Staff Report to the
Municipal Planning Board
April 19, 2022

CUP2022-10001

CAPITAL PLAZA BANK DRIVE THRU

Site Plan

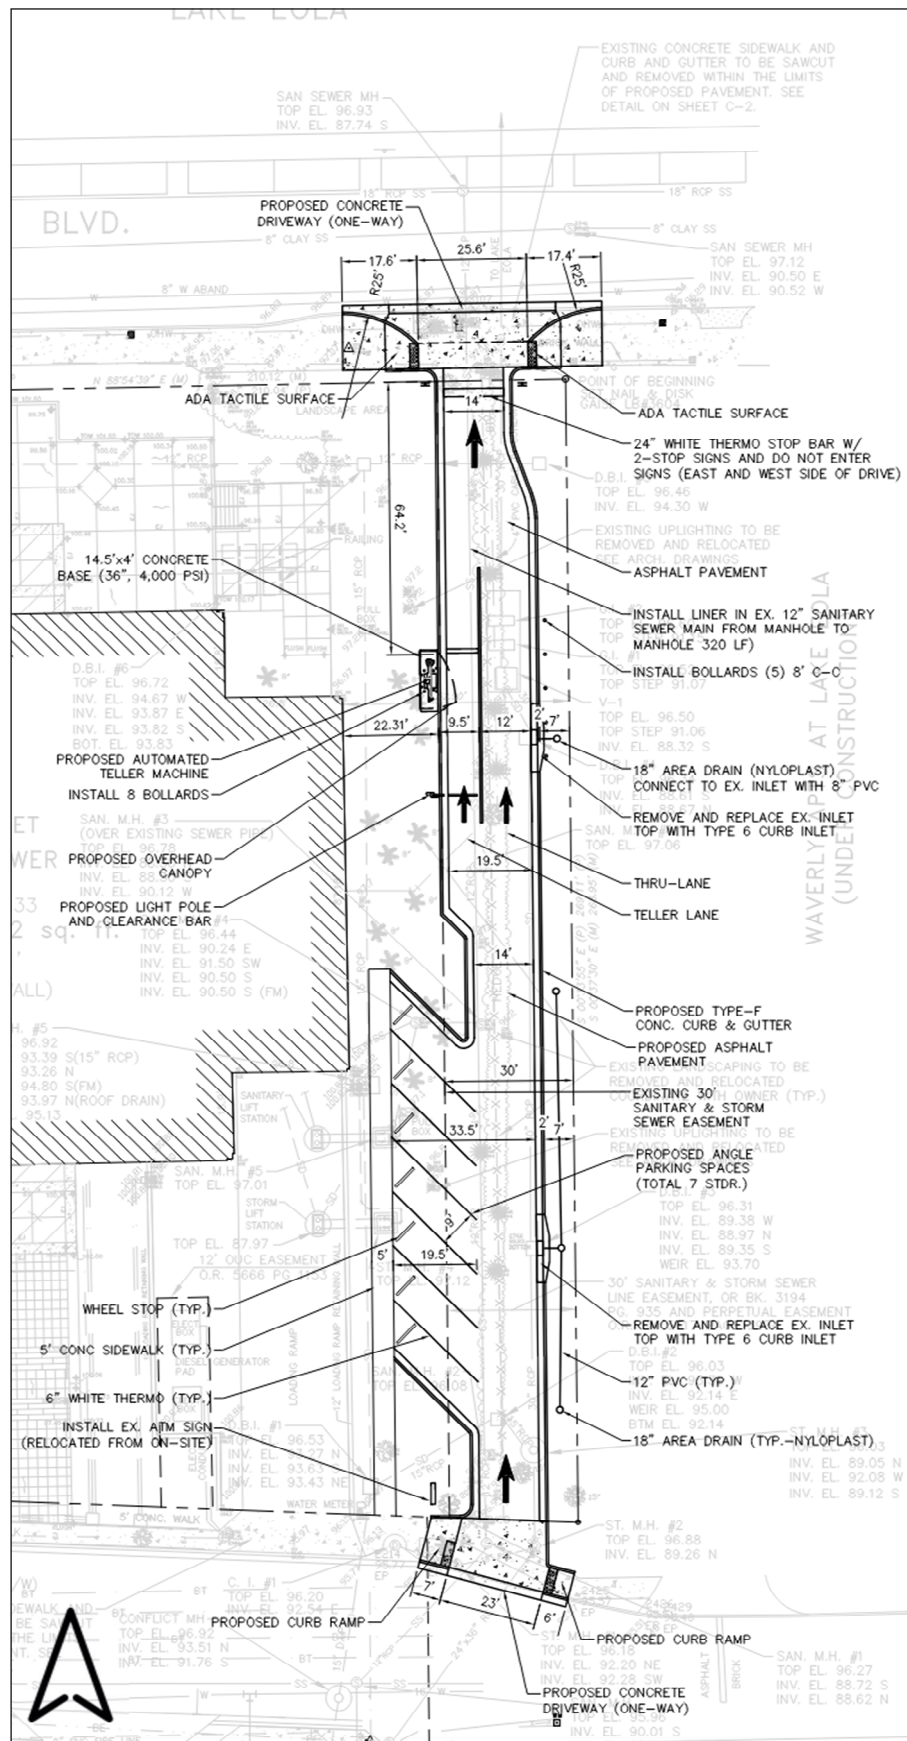
- 3. The proposed driveway on the east side of the building must be accompanied by a 7.5 foot landscaped buffer on the east side. The driveway width can be reduced to 13 feet in width to accommodate this.

- 4. The divider between the teller lane and the thru-lane is marked on the plans, but not described so it is not clear if it includes a raised curb or if it is just paint. Details on the type of divider must be provided at permitting. The teller lane width is marked on the plans as 9.5 feet in width, but this includes the gutter. Please widen the teller lane to at least 10 feet not including the gutter.

1. Shift the location of the ATM closer to the street to increase the visibility as seen from the street. The current location is screened by the building which can obstruct some visibility.

Landscape Plan

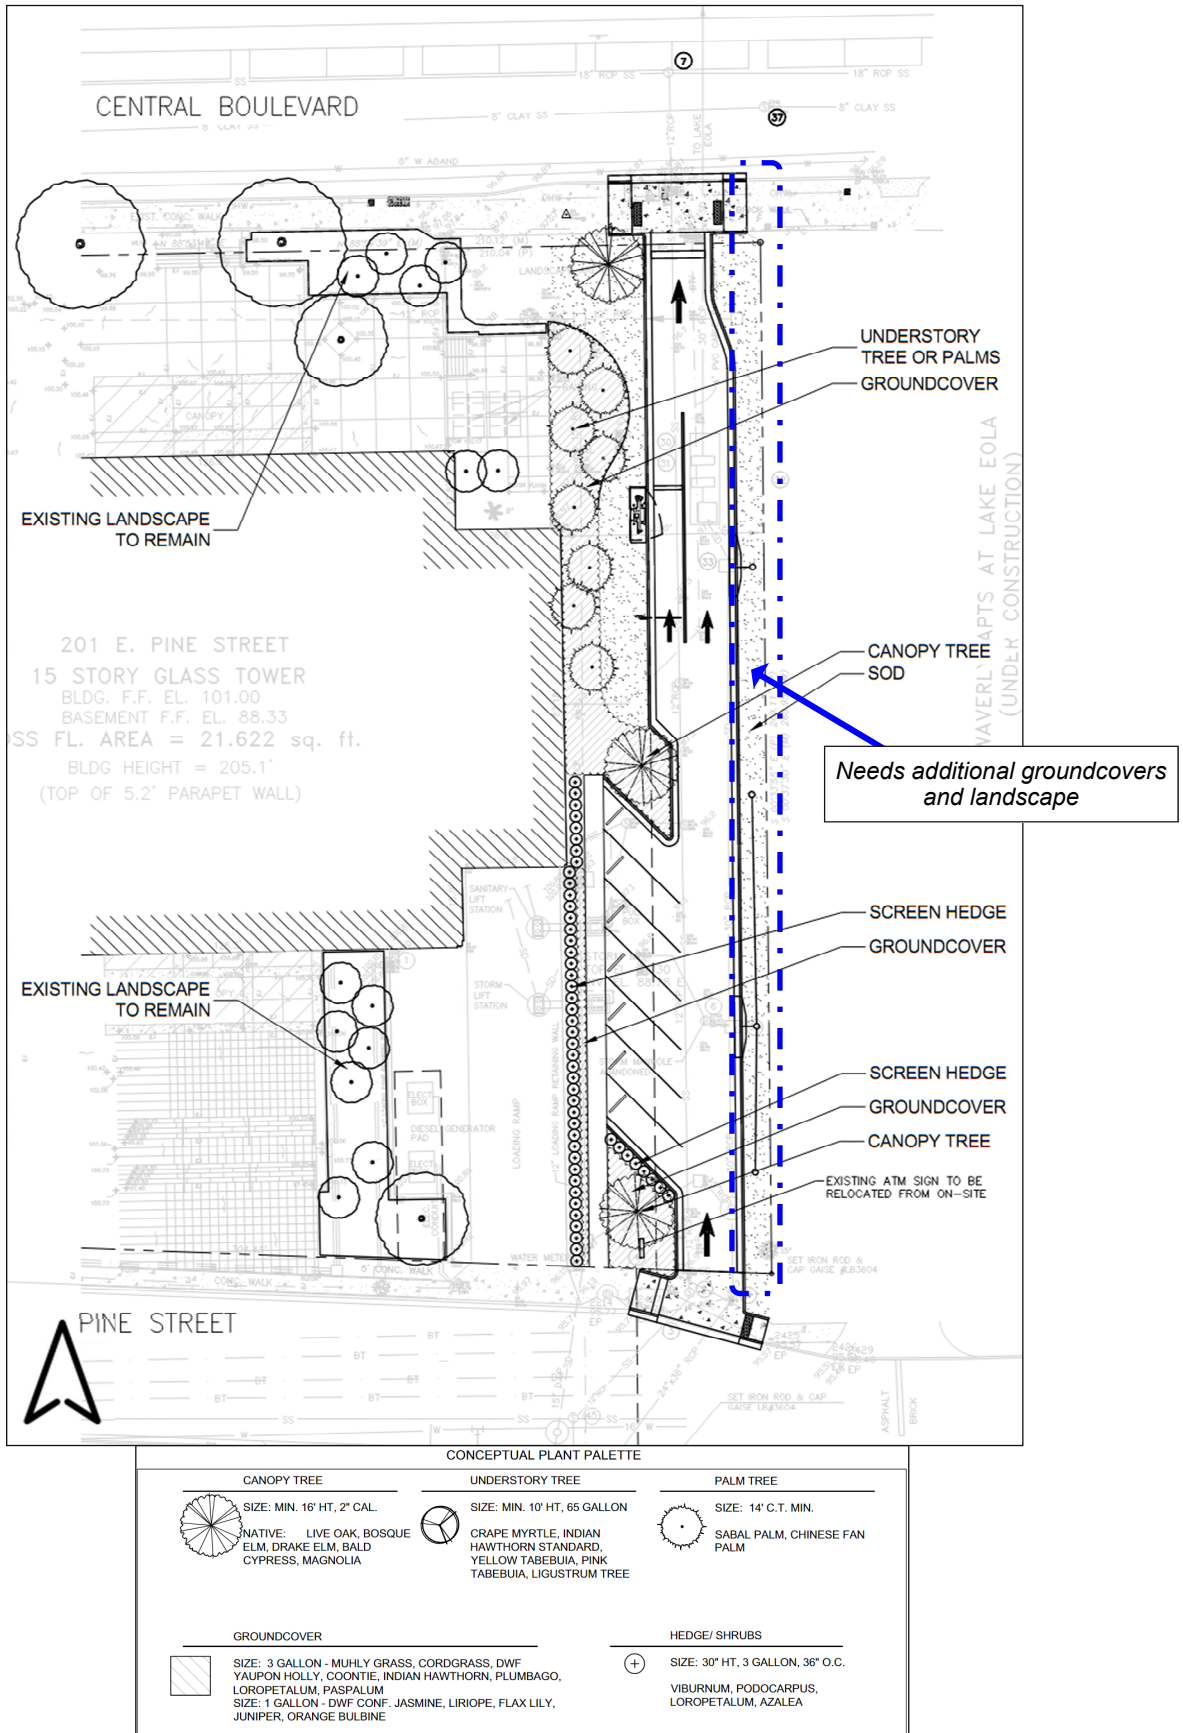
The proposed bank drive-through abuts a residential tower to the east and commercial properties to the west. Per LDC Section 60.219, Figures 6 & 7, the intensities of existing adjacent uses are less than or similar to the proposed use. A 7.5 ft lot line buffer along the property lines is required as prescribed by LDC Section 61.312(a7). Applicant proposes a 7 ft. grass area along the east property line, staff is requesting additional ground cover and plantings along the eastern property line where possible.

- A. Use understory trees rather than palm trees in planter area to the west and north of the ATM to provide more effective screening.
- B. Provide additional ground cover and plantings along the eastern property line where possible.
